The Commission has issued the enclosed Amendments Nos. 5 and 3 to Facility Operating Licenses Nos. DPR-44 and DPR-56 respectively, for the Peach Bottom Atomic Power Station, Units No. 2 and 3. These amendments include Changes Nos. 6 and 3 respectively and are in response to your request of July 12, 1974.

These amendments revise the provisions in the Technical Specifications relating to fuel densification. Operation of the facilities will be within the limits and restrictions of both the change to the Technical Specifications and the Emergency Core Cooling System evaluation.

AMENDMENT TO FACILITY OPERATING LICENSE

(CHANGE NO. 6 TO THE TECHNICAL SPECIFICATIONS)

Figure 3.5.1.A

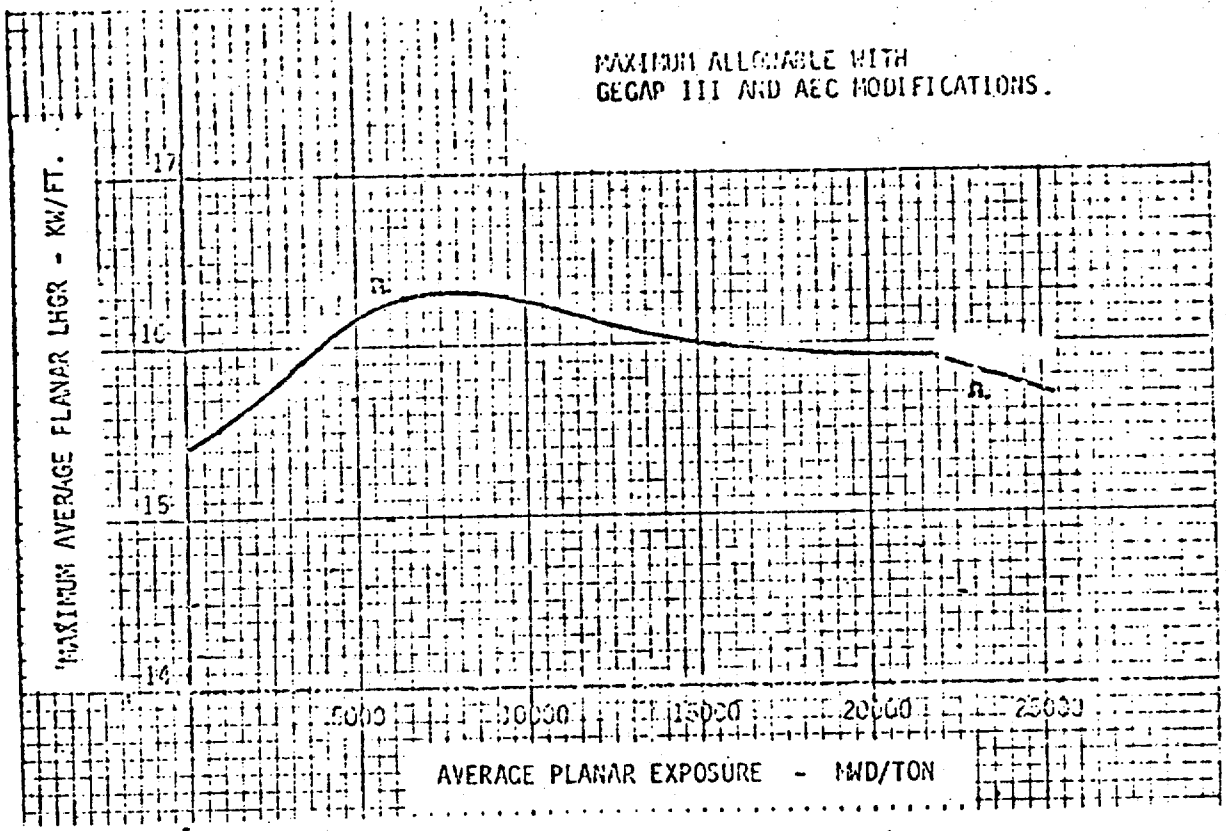
During steady state power operation, the average linear heat generation rate (LHGR) of all the rods in any fuel assembly, as a function of average planar exposure, at any axial location, shall not exceed the maximum average planar LHGR shown in Figure 3.5.1.A or Figure 3.5.1.B.\*

The maximum average planar linear heat generation rates shown in Figures 3.5.1.A and 3.5.1.B are based on calculations employing the GEGAP III model described in the General Electric reports NEDO-20181, "GEGAP III, A Model for the Prediction of Pellet-Clad Thermal Conductance in BWR Fuel Rods," November 1973 with related proprietary information provided in NEDC-20181 (Proprietary), November 1973.

PBAPS INITIAL CORE TYPE 2

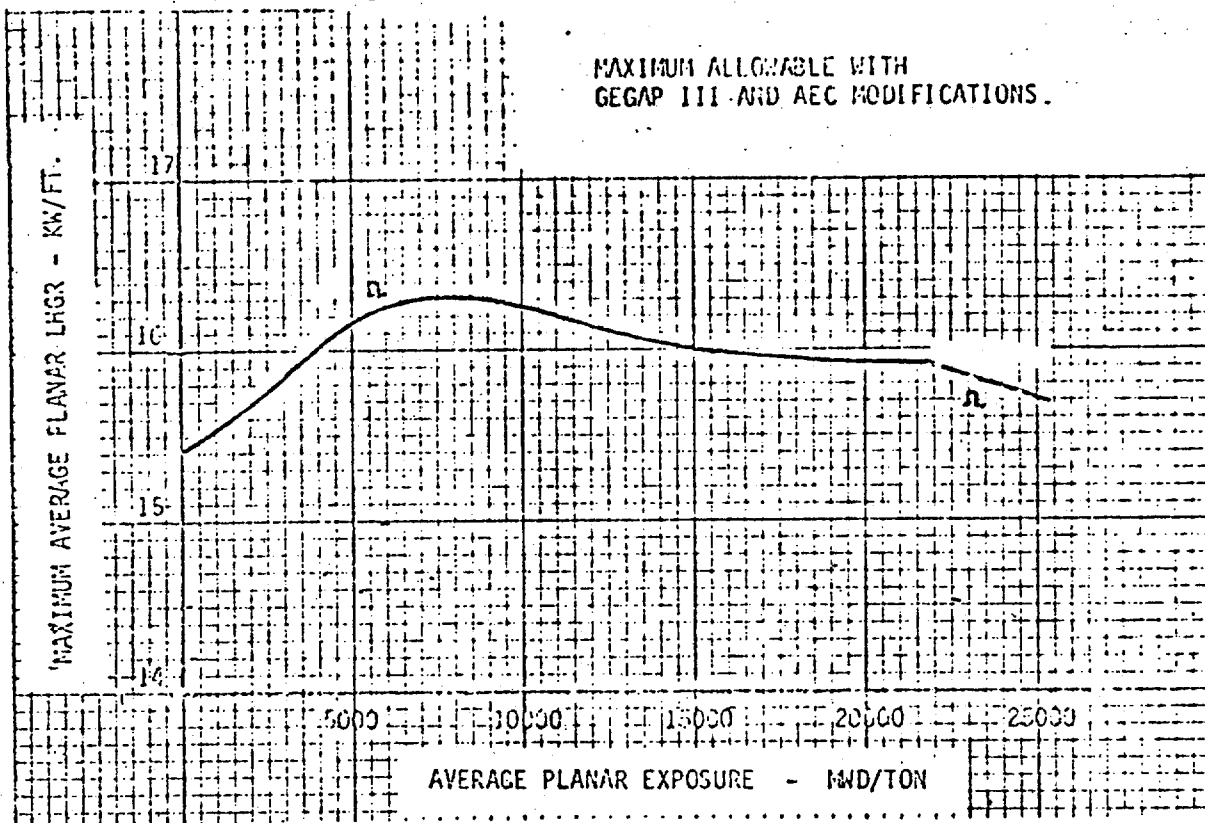
During steady state power operation, the average linear heat generation rate (LHGR) of all the rods in any fuel assembly, as a function of average planar exposure, at any axial location, shall not exceed the maximum average planar LHGR shown in Figure 3.5.1.A or Figure 3.5.1.B.\*

The maximum average planar linear heat generation rates shown in Figures 3.5.1.A and 3.5.1.B are based on calculations employing the GEGAP III model described in the General Electric reports NEDO-20181, "GEGAP III, A Model for the Prediction of Pellet-Clad Thermal Conductance in BWR Fuel Rods," November 1973 with related proprietary information provided in NEDC-20181 (Proprietary), November 1973.
